**Date:** Geneva, 26 May 2016

**Underwear overlap, Update of Art.2 "Flame resistant clothing" of APPENDIX L CHAPTER III "Drivers' Equipment"**

Figure 1 – minimum overlapping at the neck area

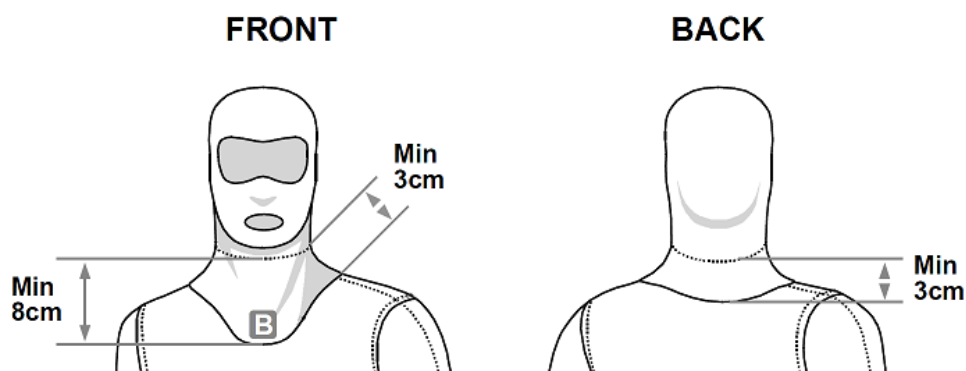
For this reason, the FIA has decided to define a minimum overlap required in the neck area (between the balaclava and the top underwear) of 3cm, except on the front central line where the overlap shall be at least of 8cm as shown in Figure 1.
